Construction Change Directive

PROJECT: *(name and address)*
Highland Township Fire Station 2
PIA #18-122B

CCD INFORMATION:
Directive Number: 001
Date: July 13, 2021

“EXHIBIT A” – CCD NO. 1

C-4 SITE STORM SEWER PROFILES

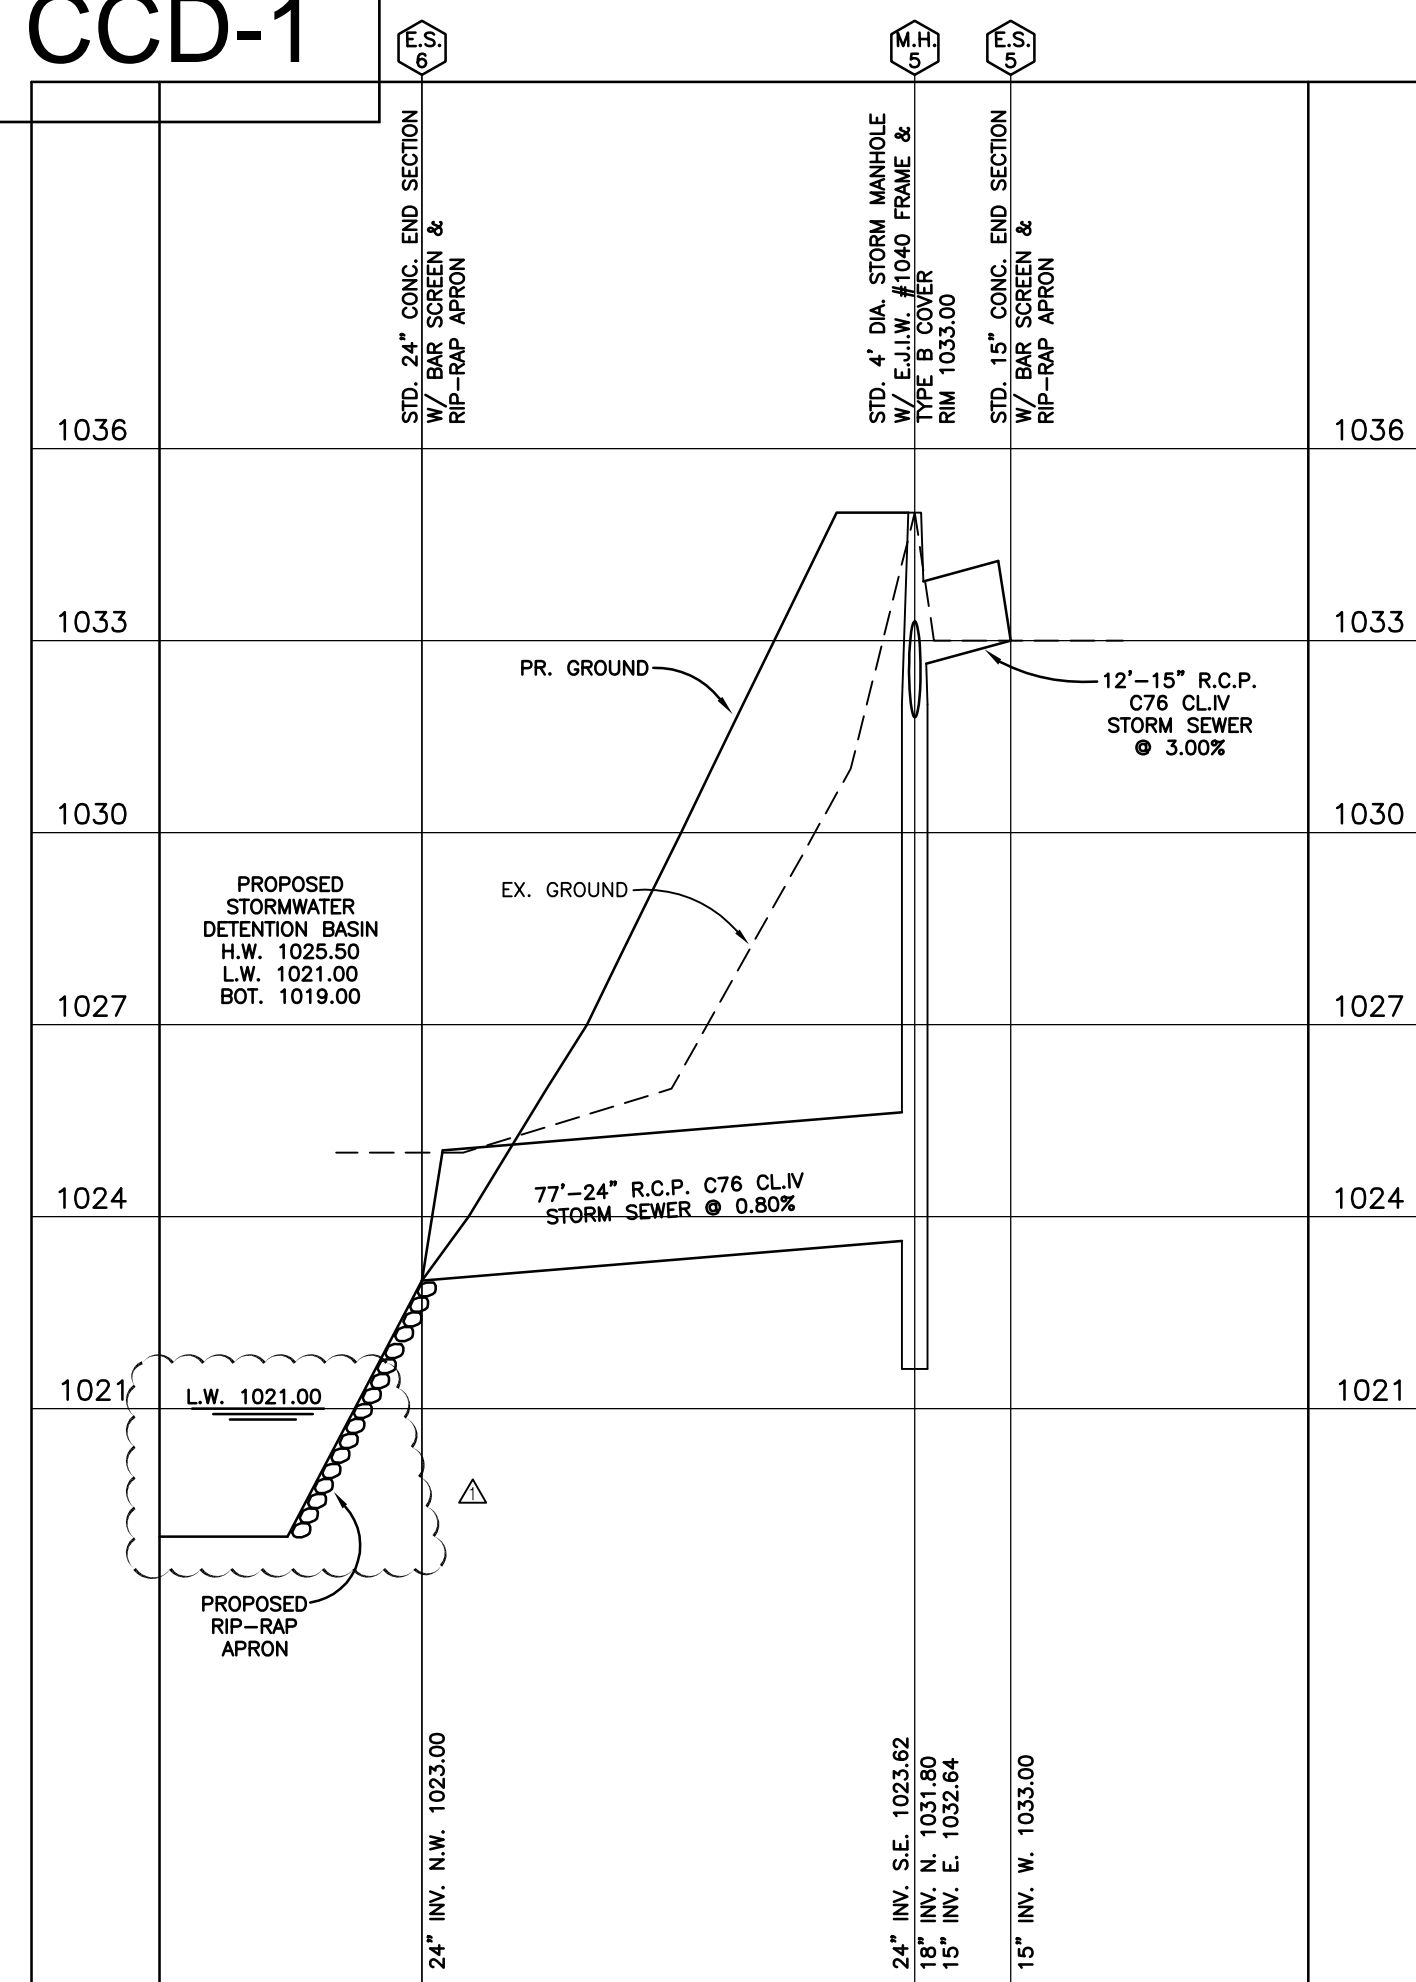
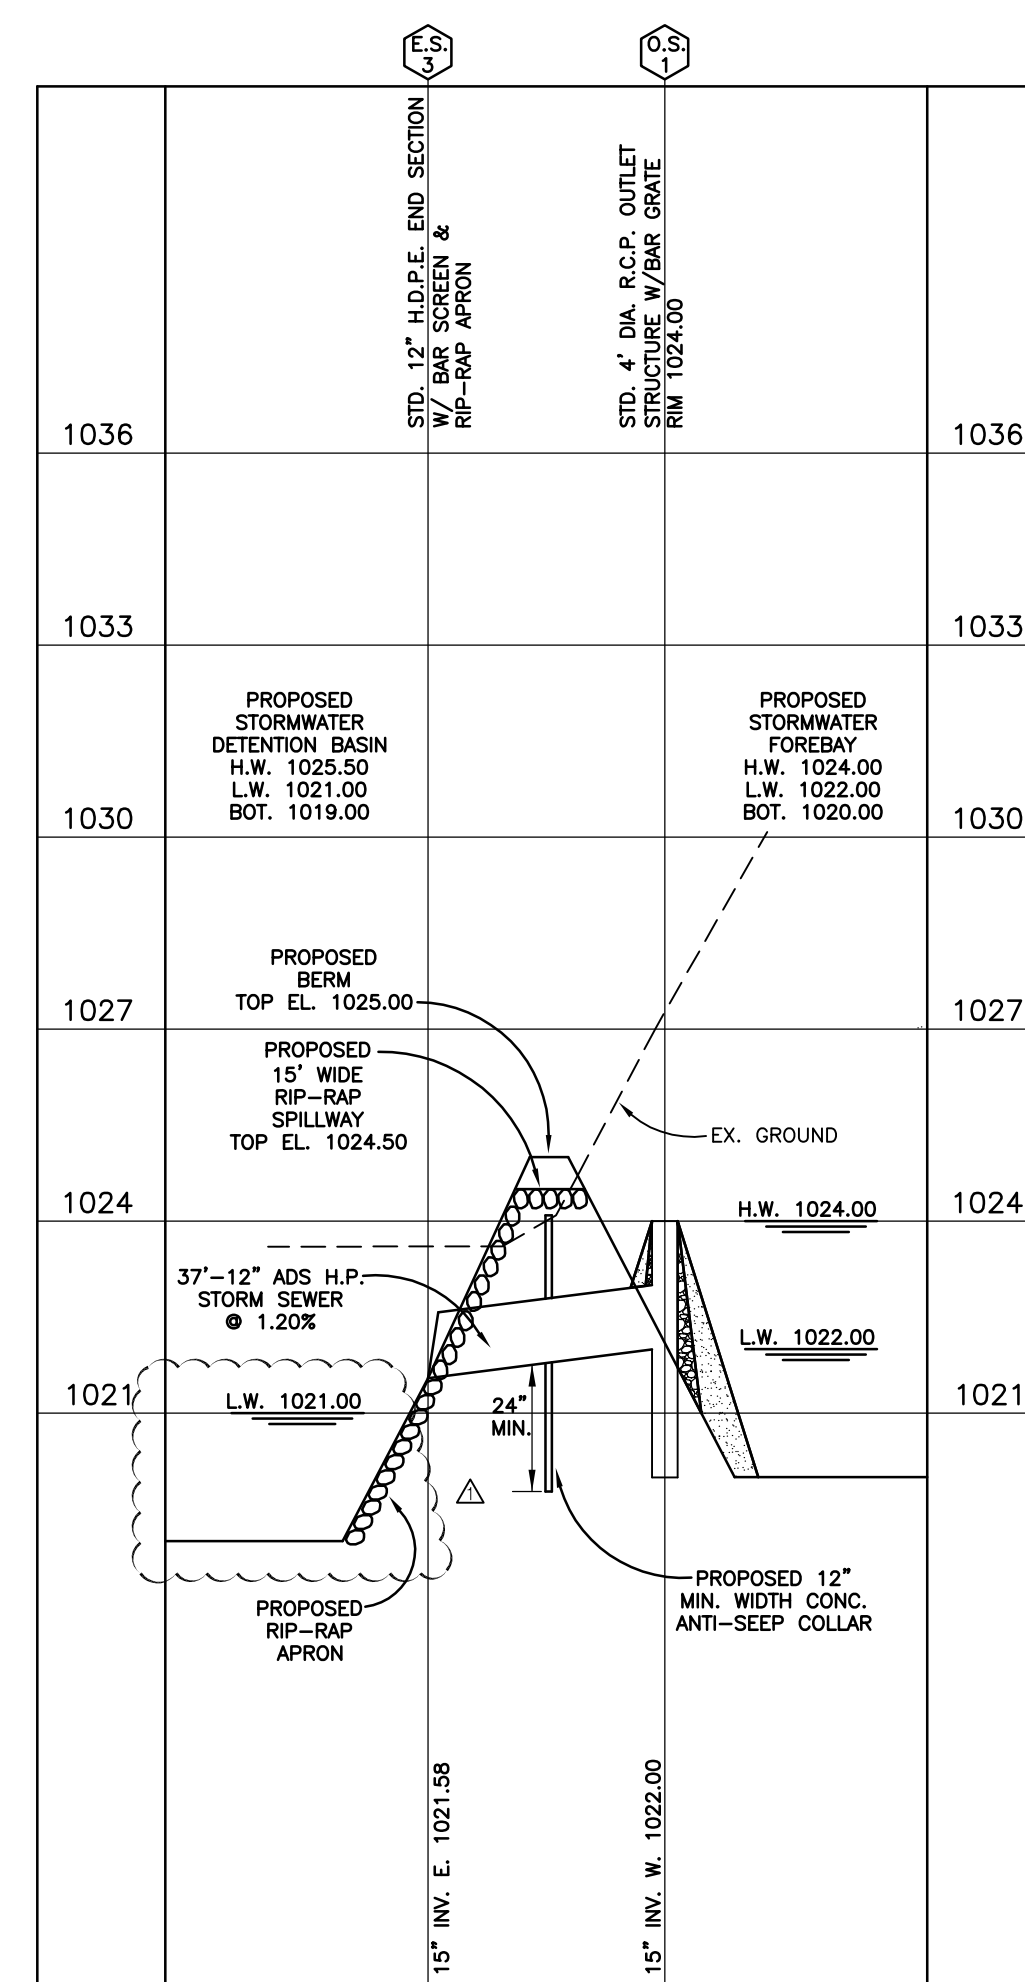
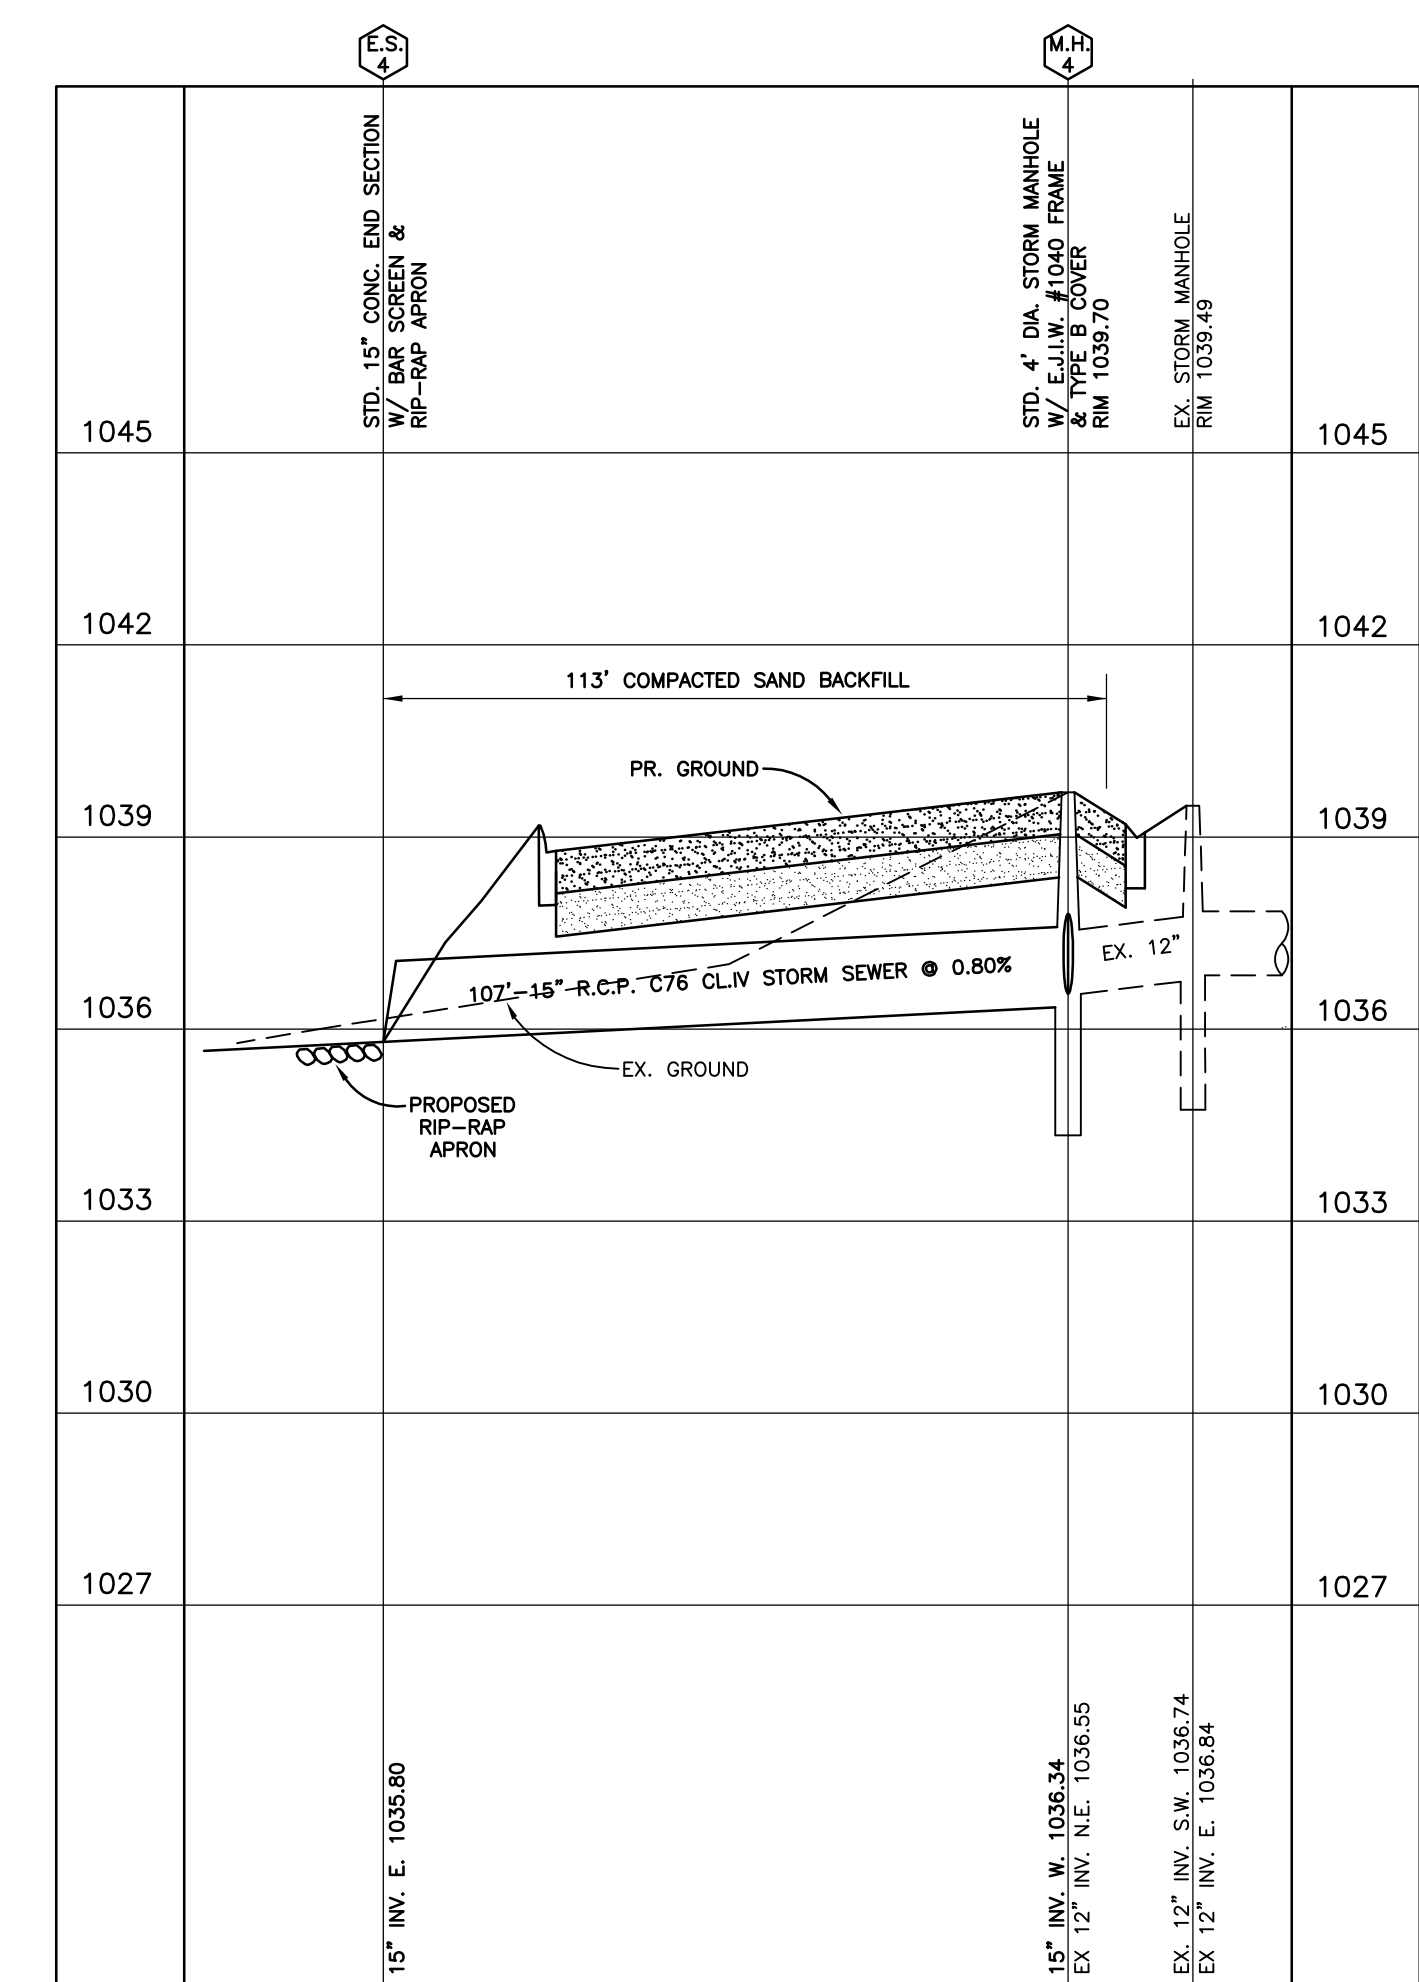
- A. Added 2' deep sediment sump in Stormwater Detention Basin.
